Service-Information Motorcycle

Frame

46 031 91
(2448)

R100GS/R100GS P-D Saddlebag Mounts - 1991 Models

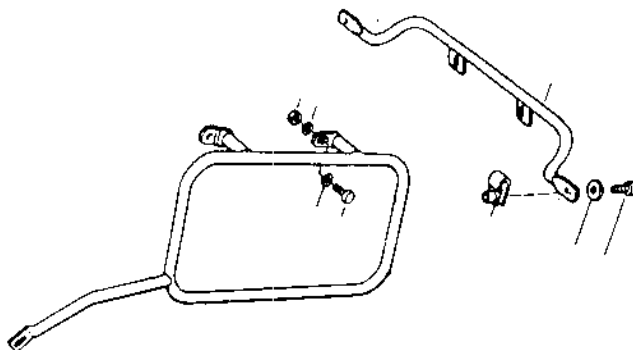
The R100GS P-D is manufactured with saddlebag mounts installed during production. The mounts are chrome plated so that they are more corrosion-resistant. A noticeable change this year is the new Matte Black cross support which improves the strength of the saddlebag mounts in rough-duty applications:

72 60 2 315 680 - Case Rod Chrome

72 60 2 315 678 - Case Rod Black

If your customer chooses to install saddlebag mounts, the new cross support must also be installed.

The cross support may also be fitted to 1988, 1989, and 1990 models at the owner's expense, with particular benefit during rough-duty applications.
